Warming drawers with push technique: Vertical front door misalignment

Models involved: WS 6014.0 BC, WS 6014.1E, WS 6014.1GE, WS 6015.1E, GA-15 lx

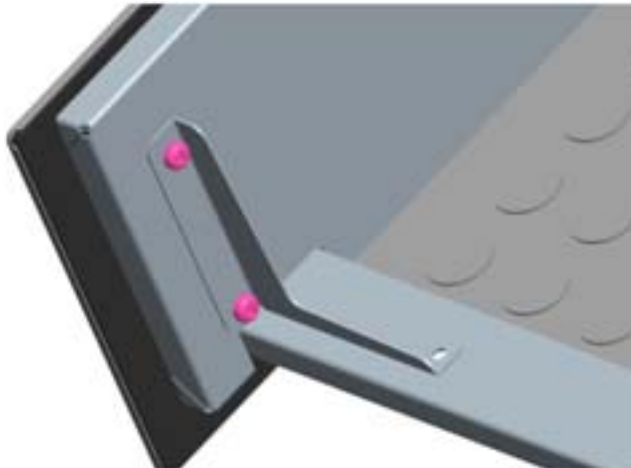
New Internal Squares to assure a more stable front drawer and to assure a right vertical alignment. These new Squares are applicable in all drawers in the field, and could be used to solve vertical front door misalignments.

1. Remove the three screws that are fixing the tray to the slider and the back door cover to the front (both sides).
2. Place the square in position and apply the two screws on the back door cover. Repeat this action on the opposite side.
3. Apply the screw on the tray and slider.

Right square spare-part no. 544519
Left square spare-part no. 544520
